# 1ST & PIKE

103 PIKE STREET

EARLY DESIGN GUIDANCE 3  
03 APRIL 2018  
DPD #3028428

3. ROOF AMENITY

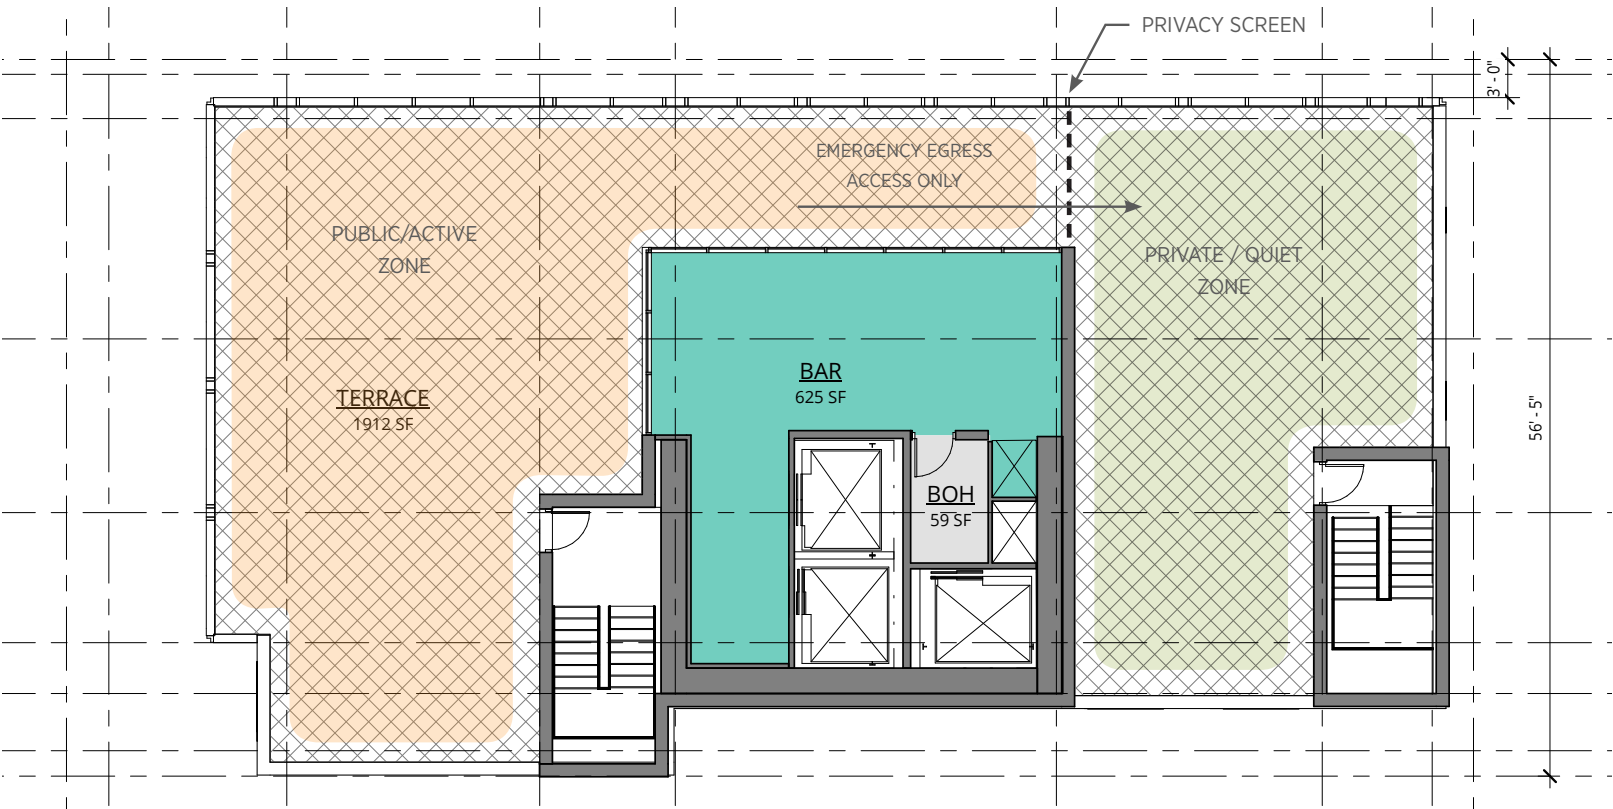
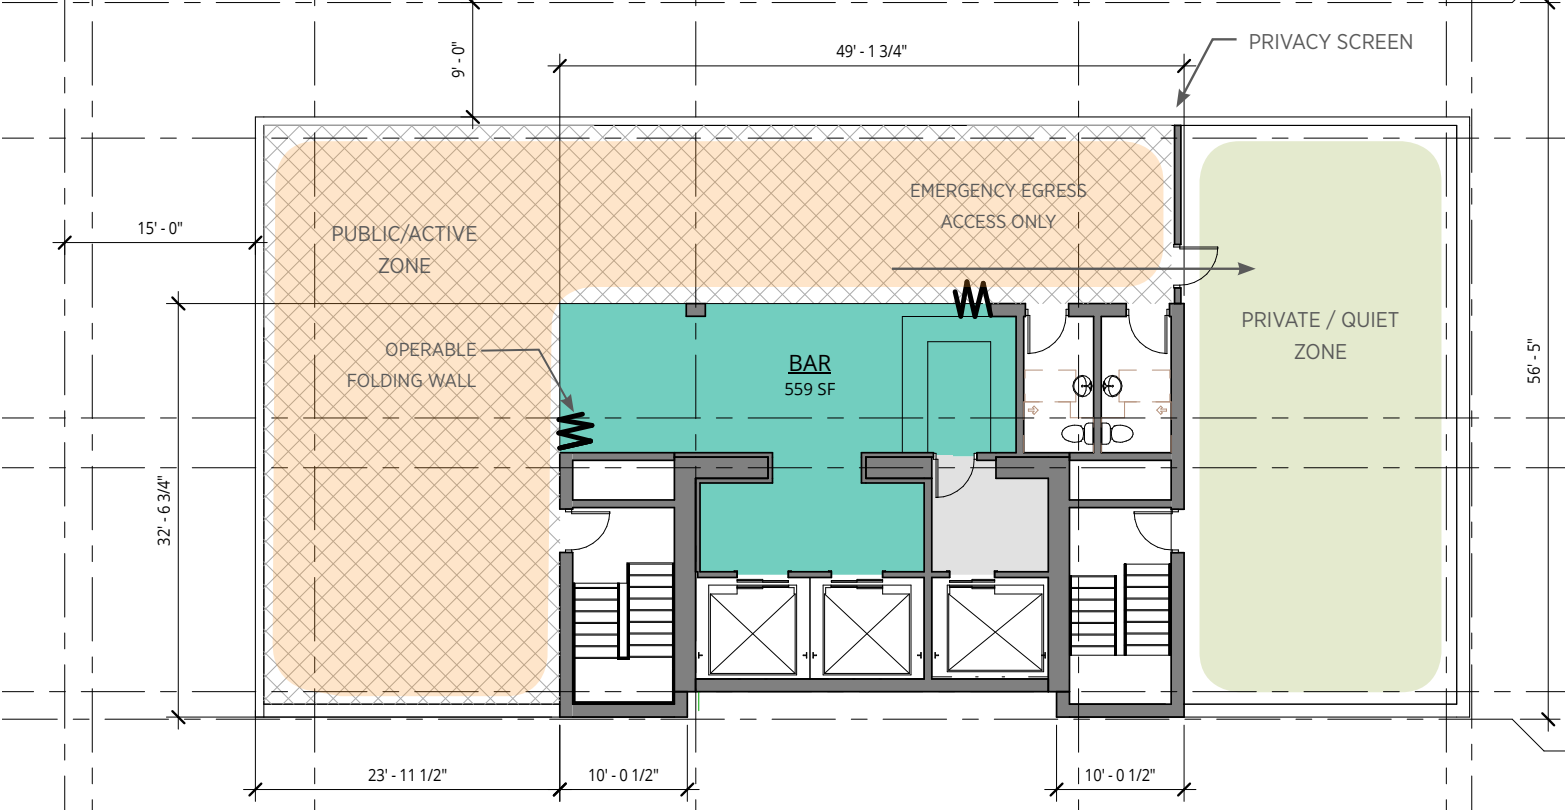
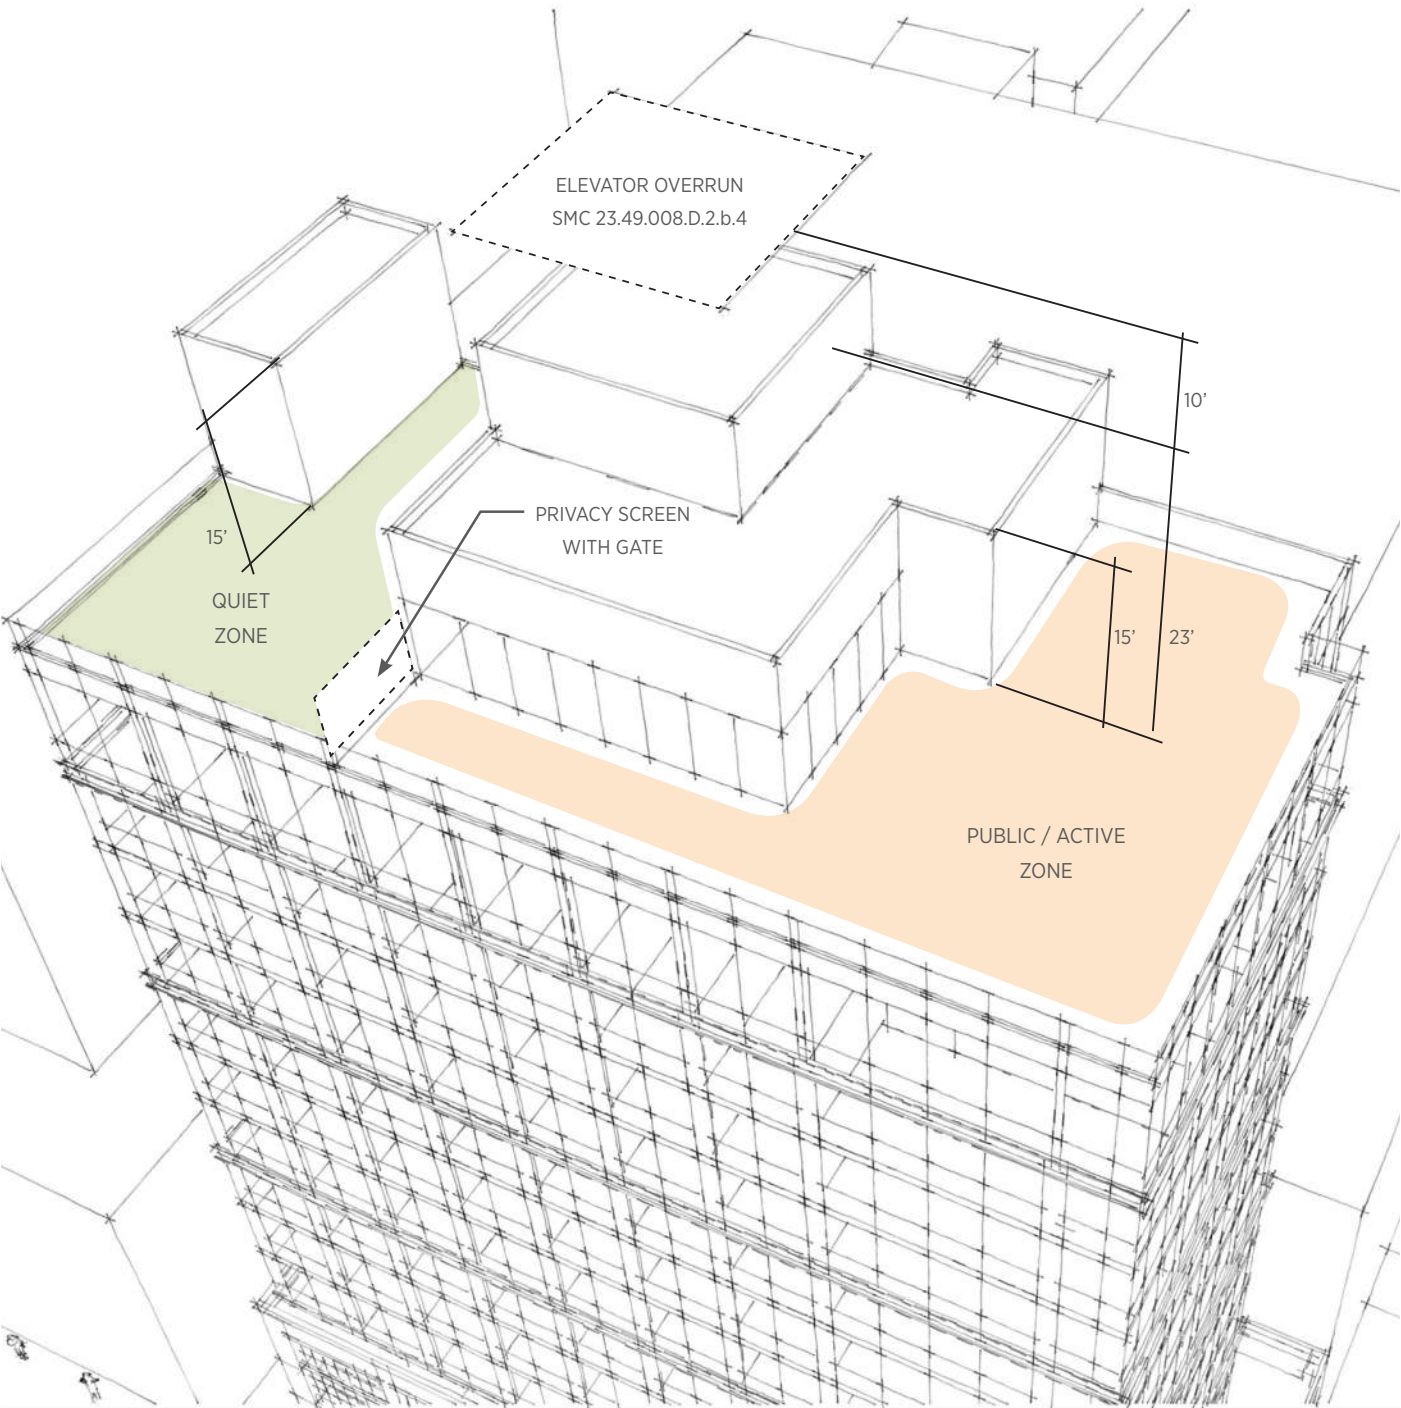
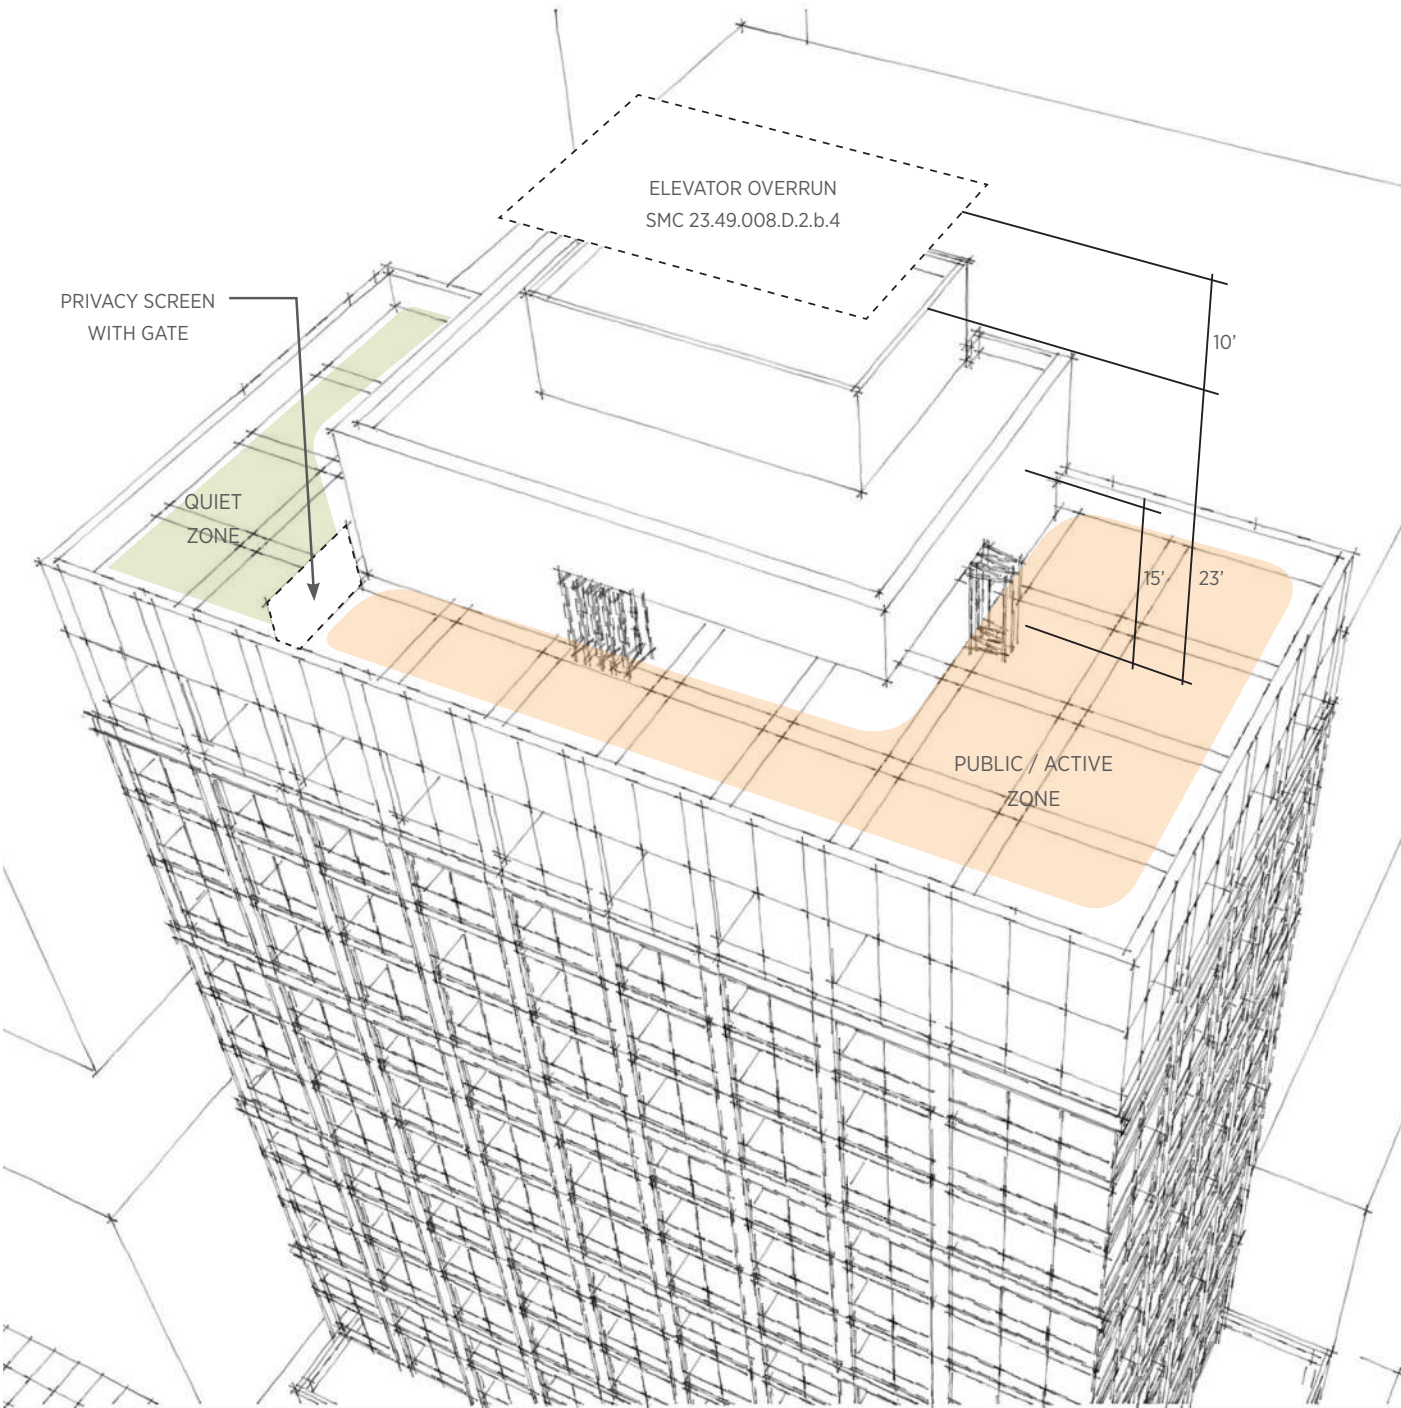
The Board acknowledged public comments concerning the rooftop concept design (noise, height, etc.). Overall, the Board reiterated continued support for the direction in which the conceptual design is headed and reemphasized that the roof-level amenity area, inclusive of elevator overruns and rooftop equipment, should be a coherent/holistic composition and designed/considered as the 5th facade due to its visibility to development in vicinity of the project site. The Board anticipates that design details (landscaping, hardscape, screening, etc.) will be provided at the Recommendation phase.

The rooftop amenity has been carefully designed to ensure privacy for the neighboring condo building. The outdoor area is divided by the overrun and bar into two distinct zones: active and quiet. More design information, including hardscape and landscaping, will be provided at Design Review.

## 4. SOUTH FACADE

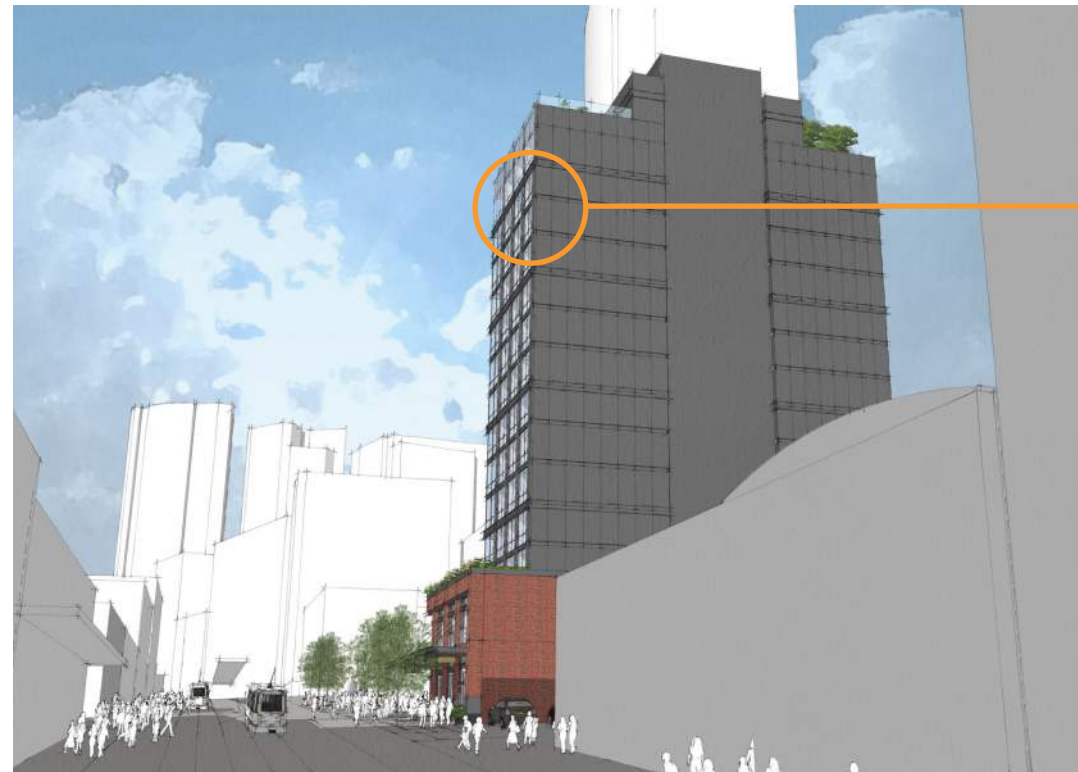
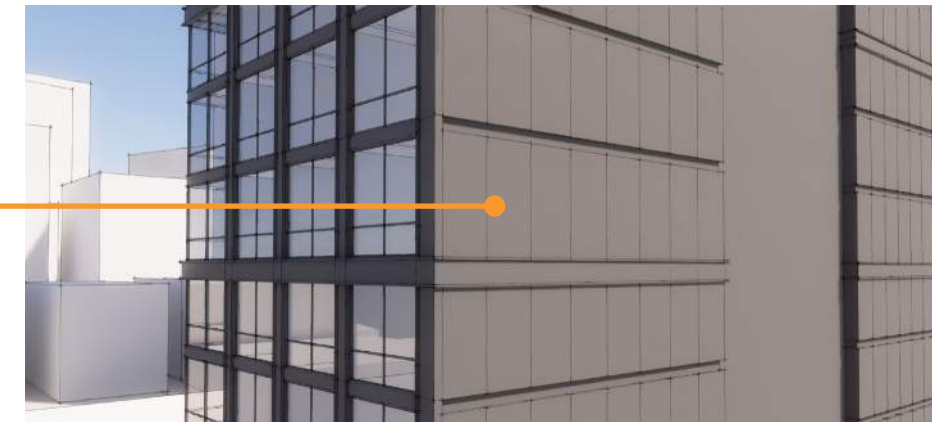
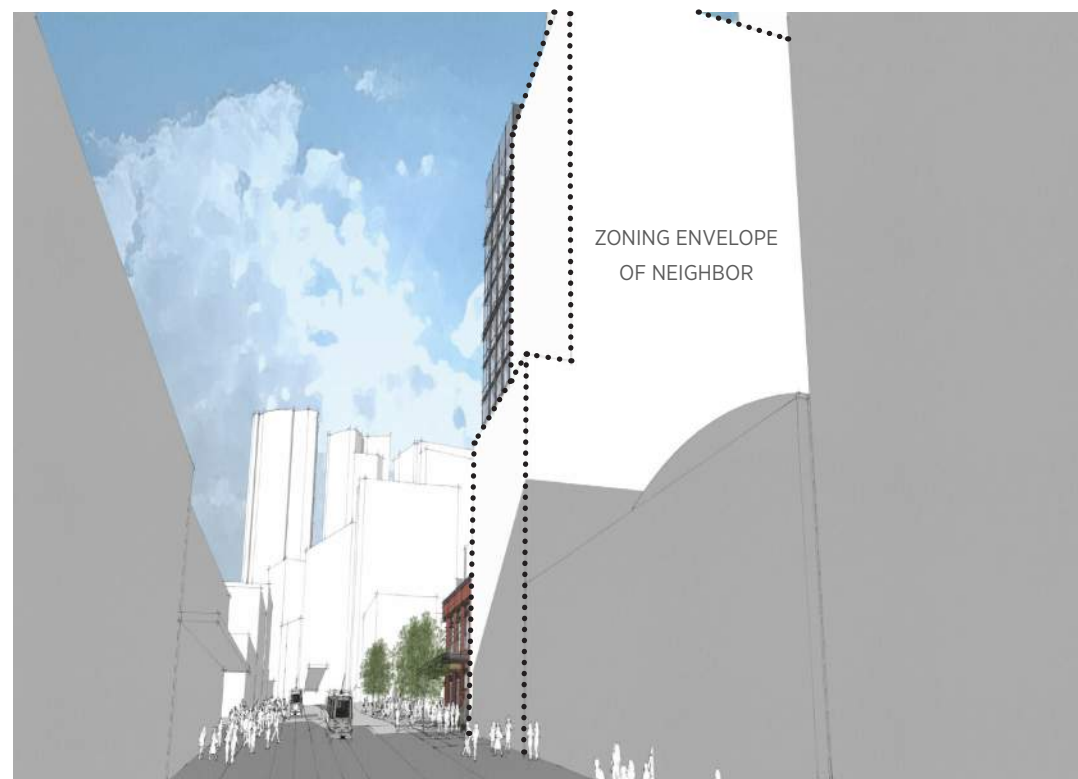
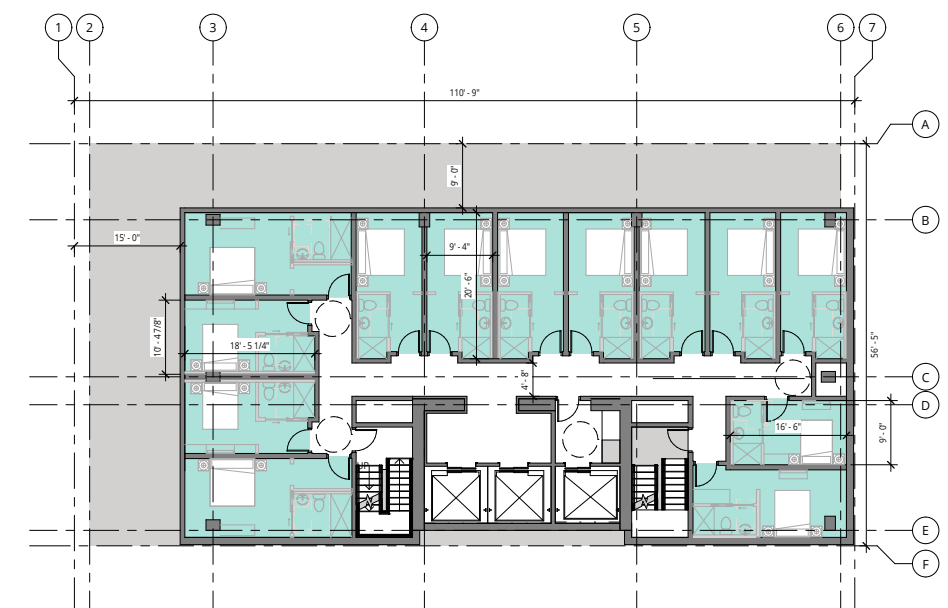
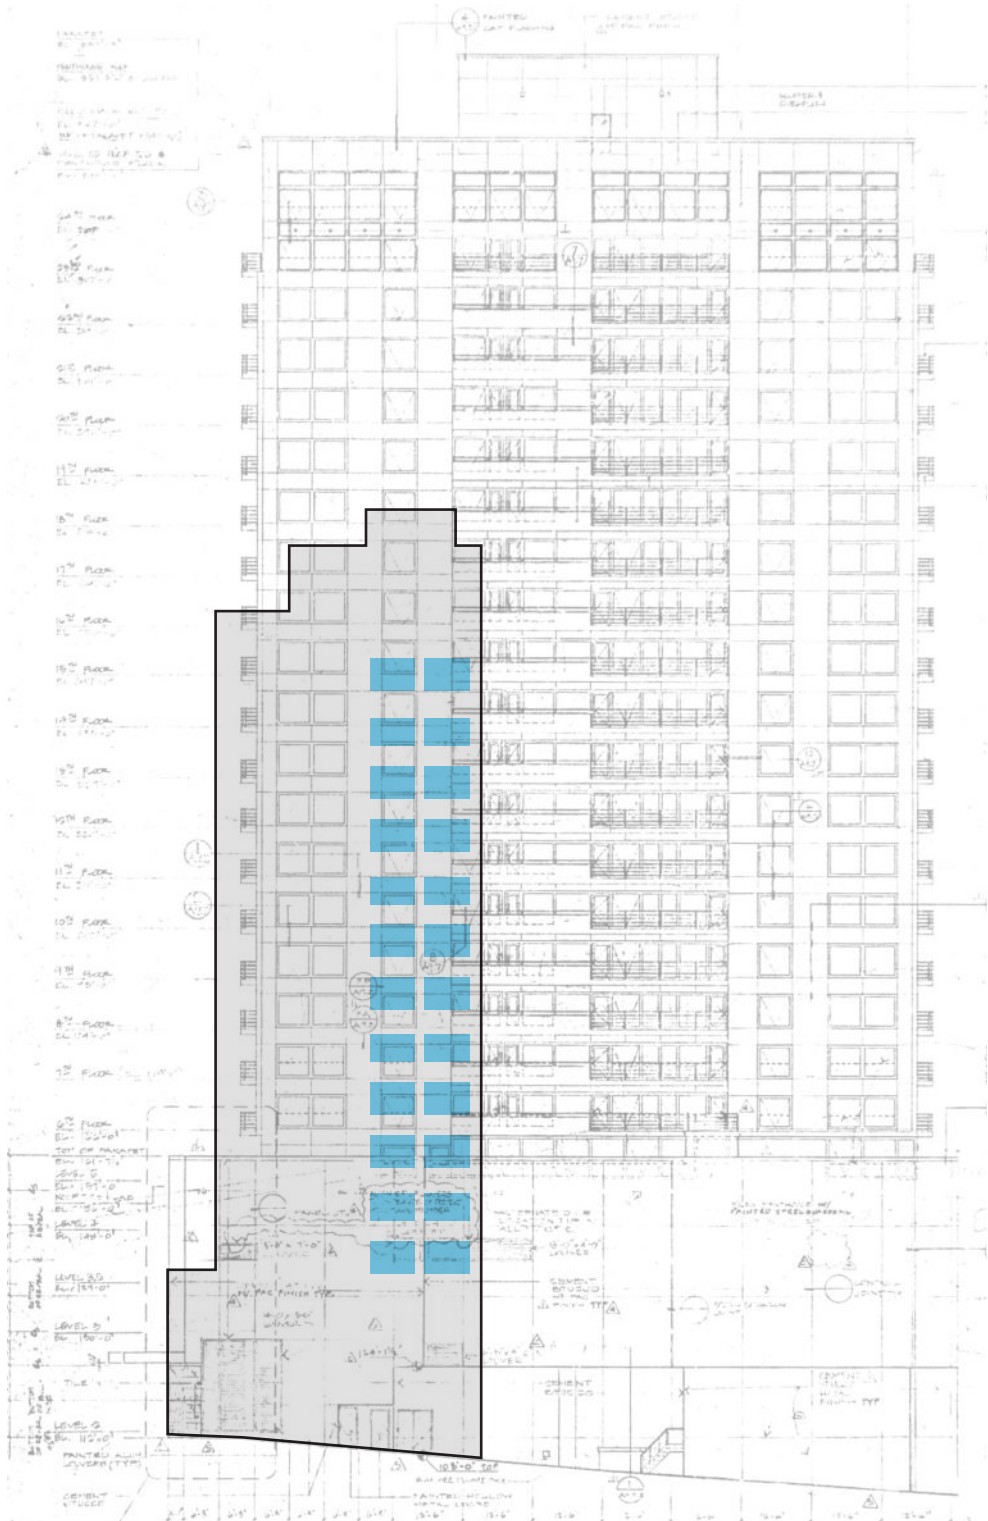
The Board understood the design team's rationale of intentionally postponing details pertaining to the design's east and south facades to the Recommendation meeting. In addition to the Board direction from the first EDG meeting, the Board provided the following direction about the design's east and south facades:

- Carefully consider the design of the east wall facade, do not treat it like a blank party wall;
- Carefully design the south party wall.

Glazing has been added to the east wall facing the alley. Details to further articulate the facade will continue to be developed for Design Review. The south facade party wall may include an artwork feature to connect to the artistic characteristics of the Market.
